**PHILADELPHIA ELECTRIC COMPANY**

March 14, 1983

Subject: Limerick Generating Station, Units 1 & 2  
Draft Safety Evaluation Report (DSER)  
from NRC Mechanical Engineering Branch

LIMERICK  
MEB SER QUESTIONS

References Fig 9.22, sheet 3 of 3

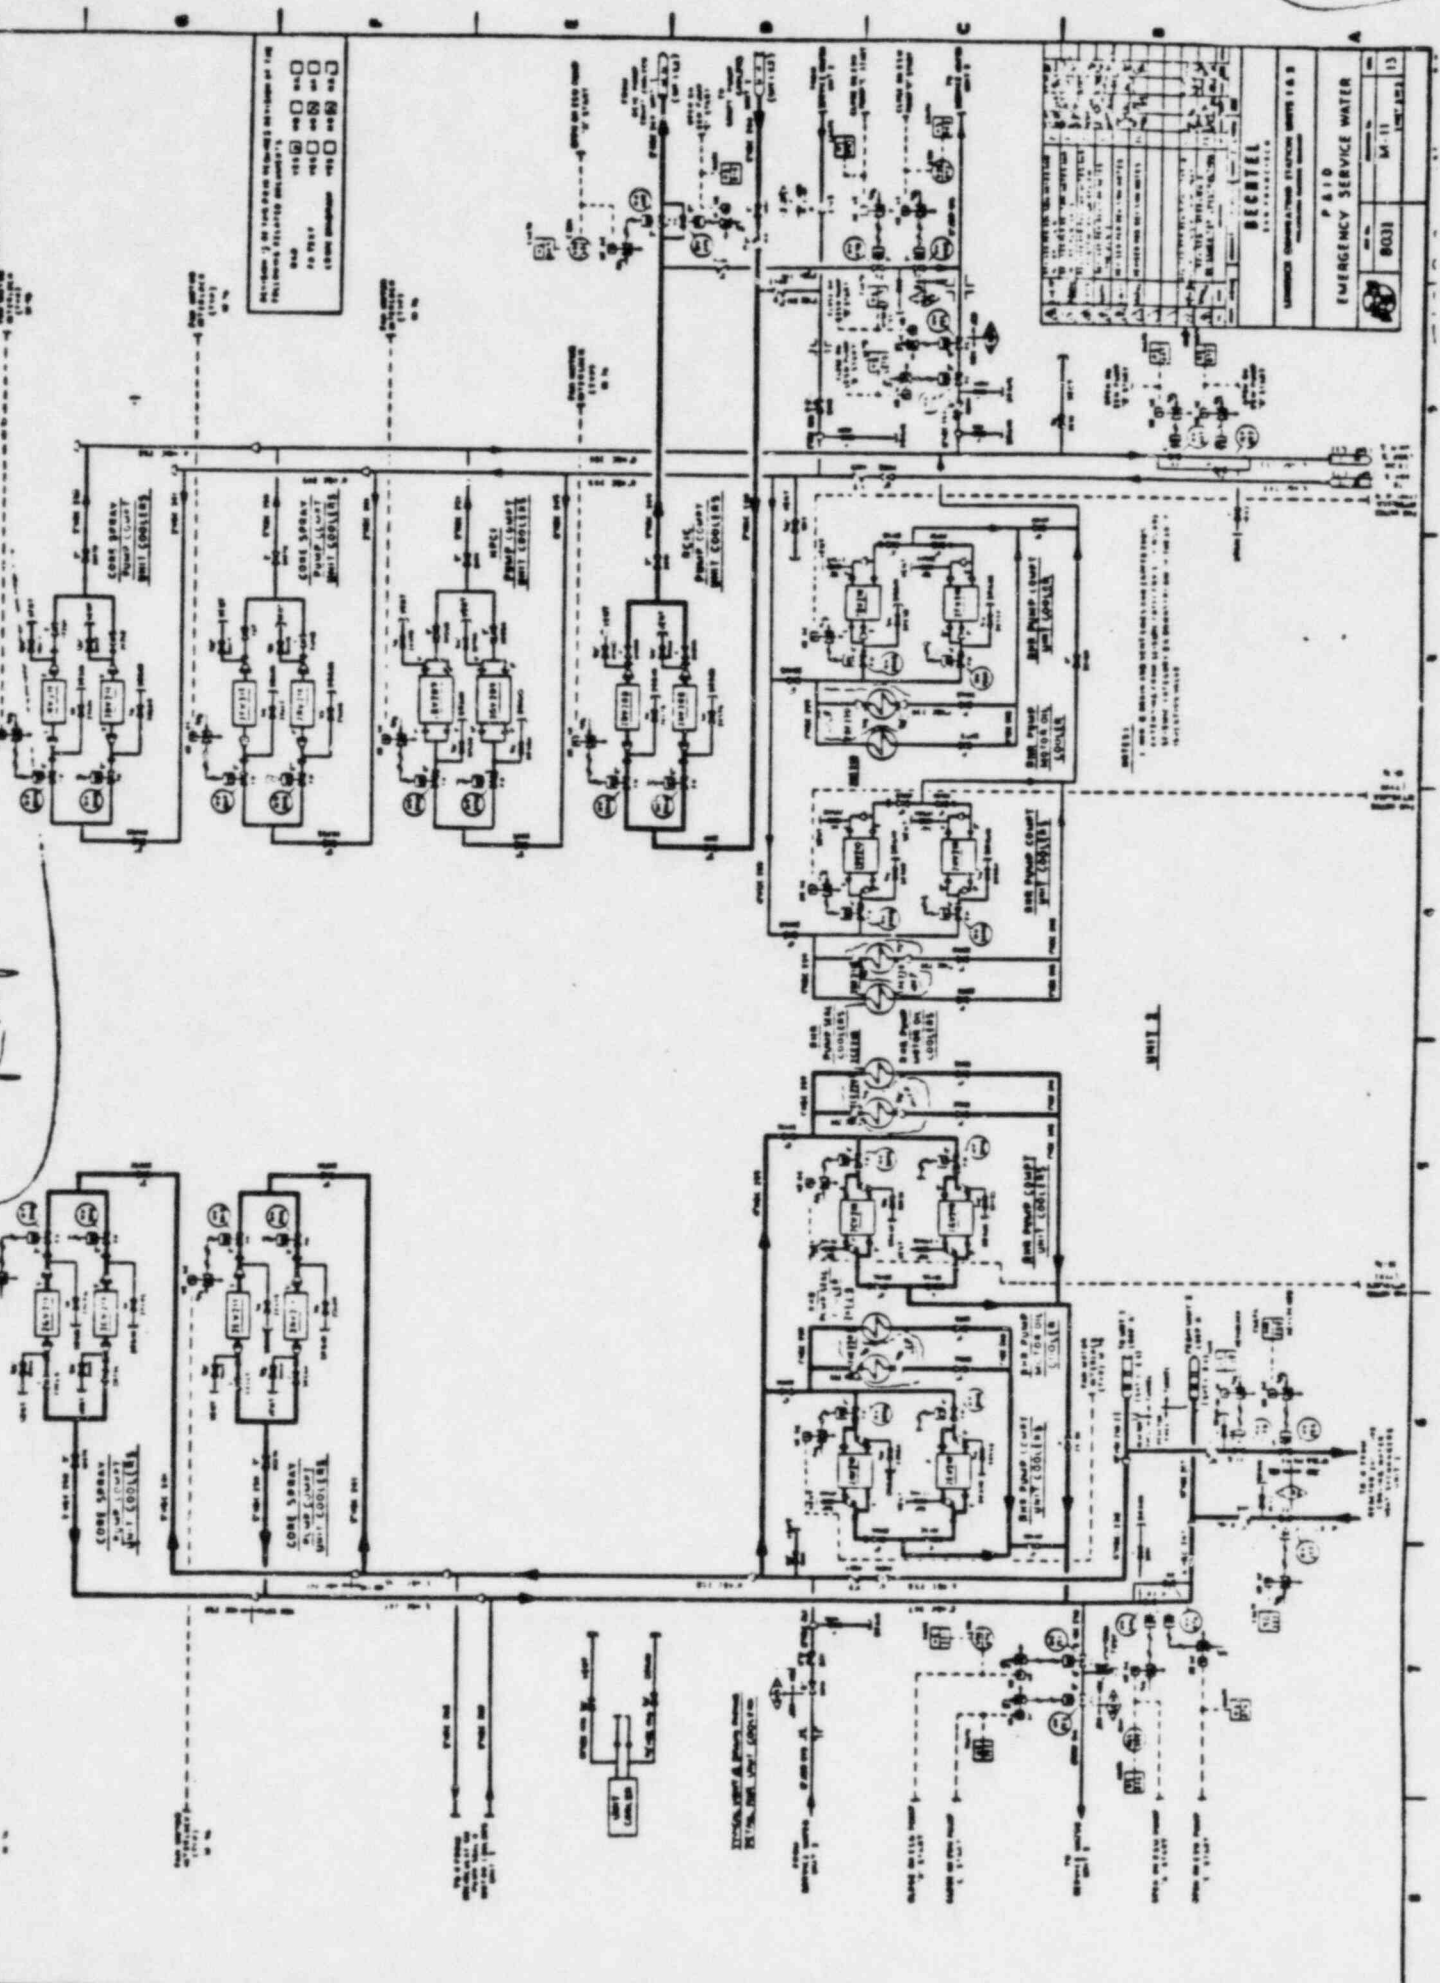
QUESTION NO. 11  
(Table 3.2-1)

What part of the Emergency Service Water System is Seismic Category IIA?

Sheets 1, 2 and 3 of Figure 9.2.2 indicate the parts of the Emergency Service Water System that are Seismic Category IIA. Non-Seismic Category I drain and vent lines and capped ends extending from Seismic Category I piping are Seismic Category IIA downstream of the last isolation valves.

LINBRIK GENERATING STATION  
 UNITS 1 AND 2  
 FINAL SAFETY ANALYSIS REPORT  
 STANDBY DIESEL GENERATOR AND  
 PLANT FUEL OIL SYSTEMS  
 sheet  
 REV. 12. 80.02

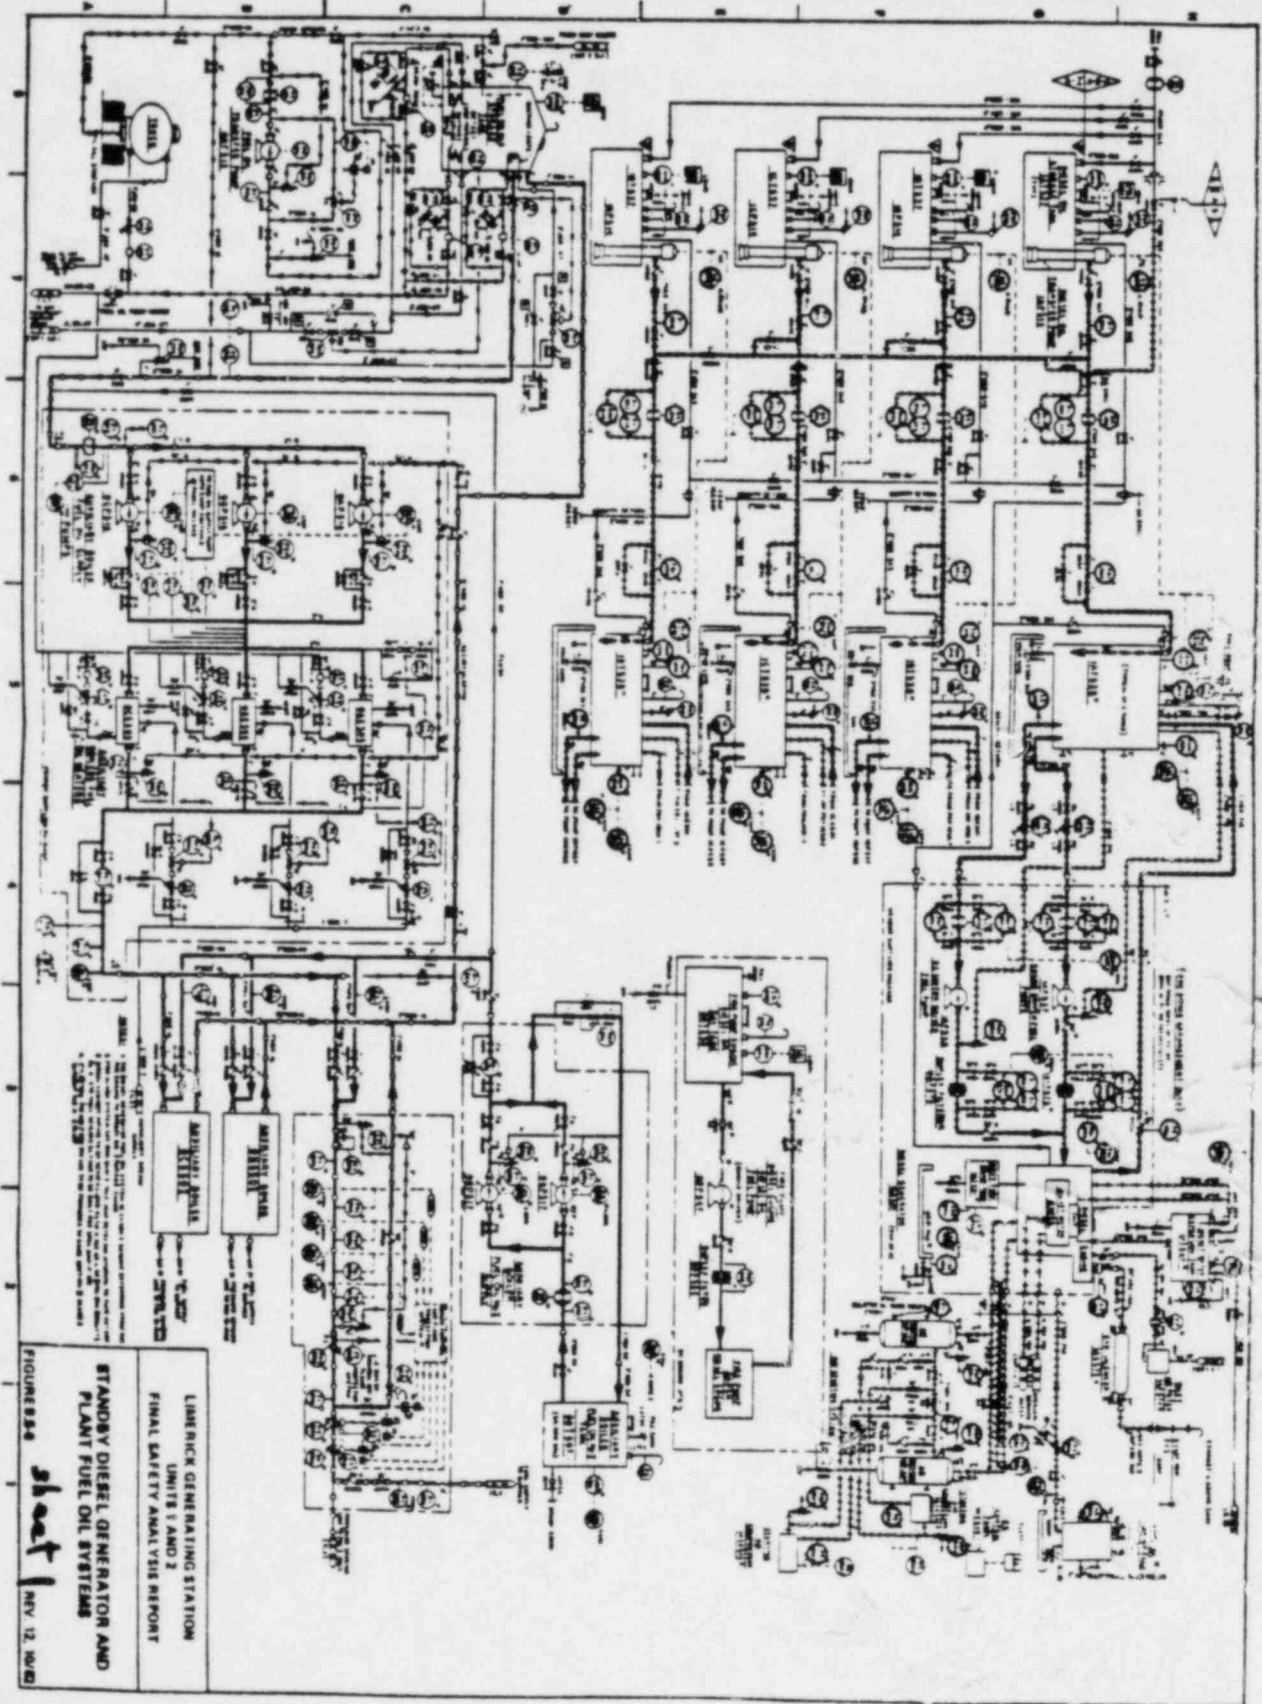
QUESTION 430.75 (Sections 3.2, 9.5.4, 9.5.5, 9.5.6, 9.5.7, 9.5.8)

Diesel generator auxiliary systems piping and components are classified in the FSAR text and Table 3.2.1 as conforming to ASME Section III Class 3, ANSI B31.1, or manufacturer's standard. It is not entirely clear where the respective classifications begin or end. In any event, this is not acceptable. We require the entire diesel generator auxiliary systems to be designed to ASME Section III Class 3, or Quality Group C, in accordance with Regulatory Guide 1.26. Revise your FSAR accordingly. Also, provide the industry standards that were used in the design, manufacture, and inspection of the diesel engine mounted piping and components. Revise the appropriate PAIDs to show where quality group changes occur.

- a. Fuel oil system (Figure 9.5-8)
- b. Cooling water system which includes the jacket water cooling loop and the air cooler coolant loop (Figure 9.5-9)
- c. Starting system (Figure 9.5-10)
- d. Lubrication system (Figure 9.5-11)
- e. Combustion air intake and exhaust system (Figure 9.5-12)

Piping and equipment in these systems is provided in accordance with ASME Section III Class 3, ANSI B31.1, and manufacturer's standards as indicated on the above referenced figures and Table 3.2-1.

Figure 1 - Generic Representation of Pipe

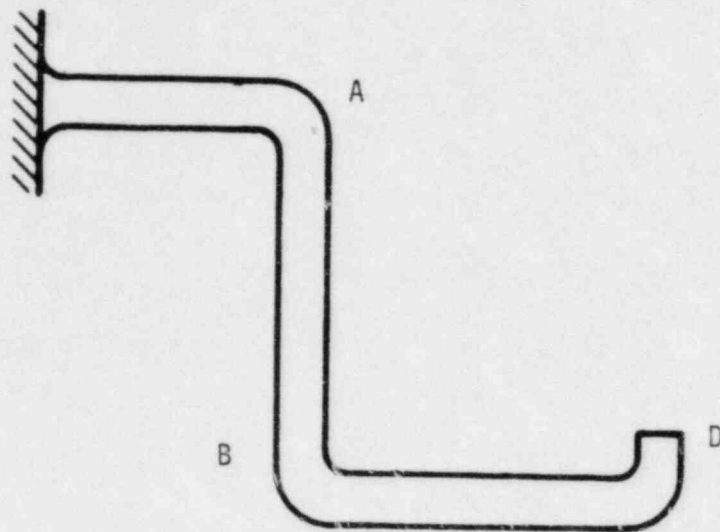
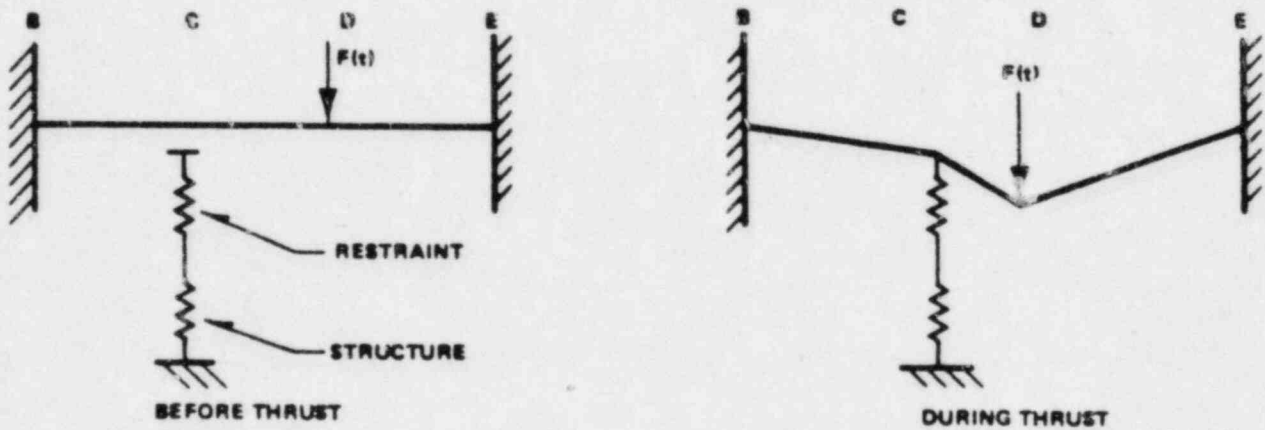
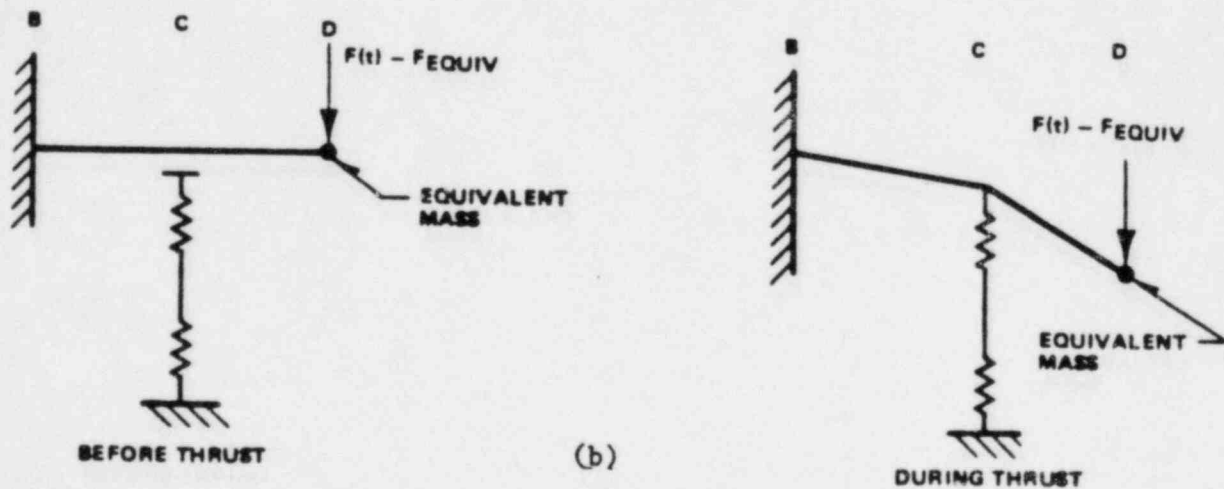
QUESTION NO. 31  
(3.6.2.2.2, Page 3.6-39)

A generic representation of the pipe in any given analysis is shown in Figure 1. If the stiffness of the piping segment located between A and B is such that:

To analyze the pipe with both ends supported (Figure 2a) with the above computer model, two simplifications are made in the piping dynamic analysis (PDA) program. First, an equivalent point mass is assumed at D instead of pipe length DE. The inertia characteristics of this mass rotating around point B are calculated to be identical to those of pipe length DE rotating around point E. Secondly, an equivalent resisting force is calculated for any deflection for the case of a built-in end from the bending moment-angular deflection relationship for pipe length DE. This equivalent force is subtracted from the applied thrust force when calculating the net energy. The new model resulting from these simplifications is shown in Figure 2b.

FIGURE 3.7-43

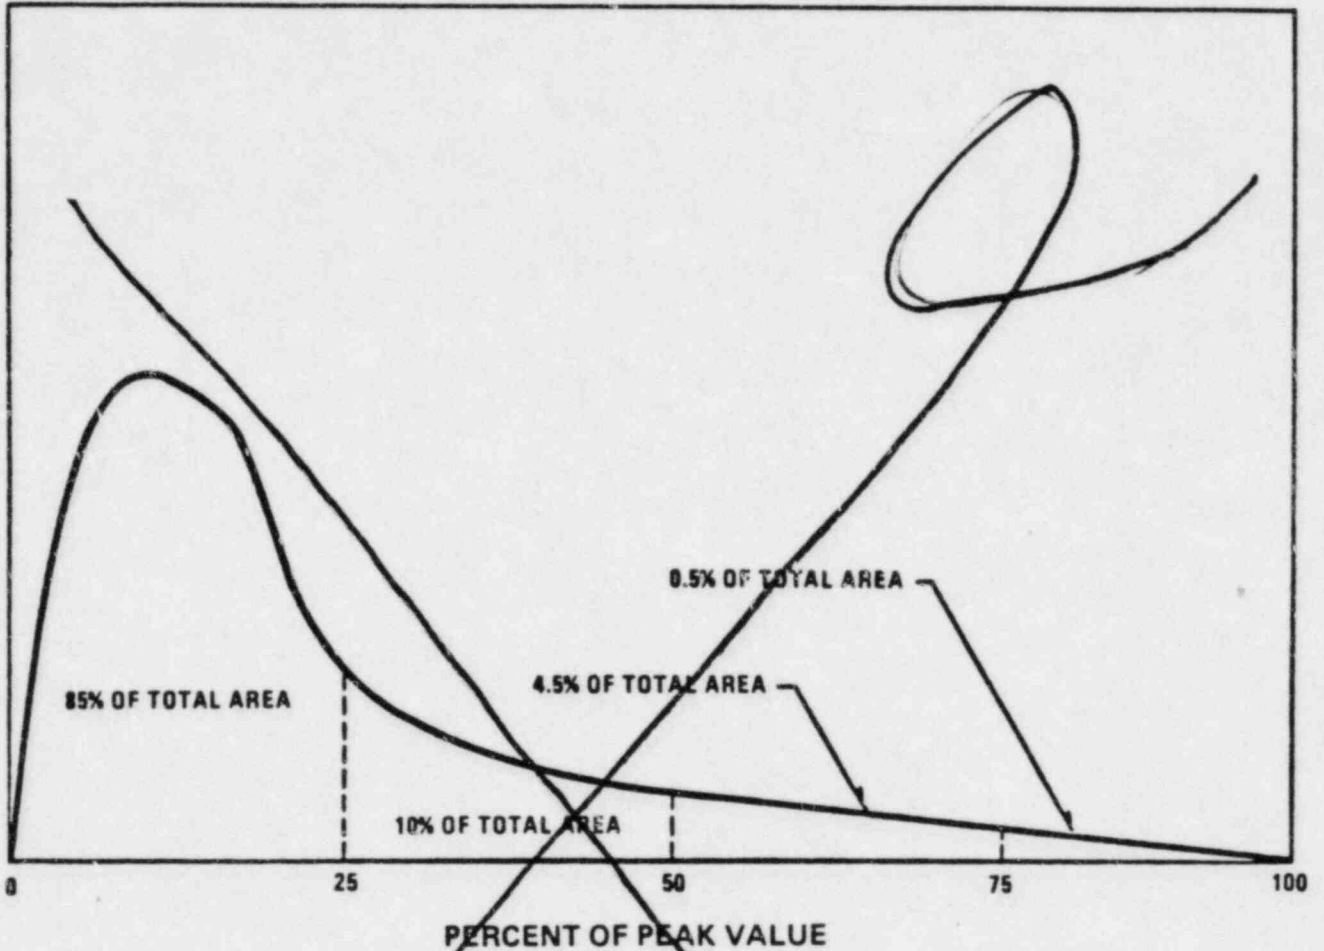
QUESTION NO. 39  
(3.7.3.2.1, page 3.7-18)

Section 3.7.3.2.1 of the LGS FSAR arrives at only one OBE intensity earthquake for design of the NSSS systems and components. Justification is required for this conclusion. Specifically, the applicant is required to provide a response to the letter from R. Boscnak (NRC) to R. Artigas (GE) dated February 18, 1982.

~~This relationship is graphically shown in Figure 3.7-43.~~

*This figure is intentionally deleted.*
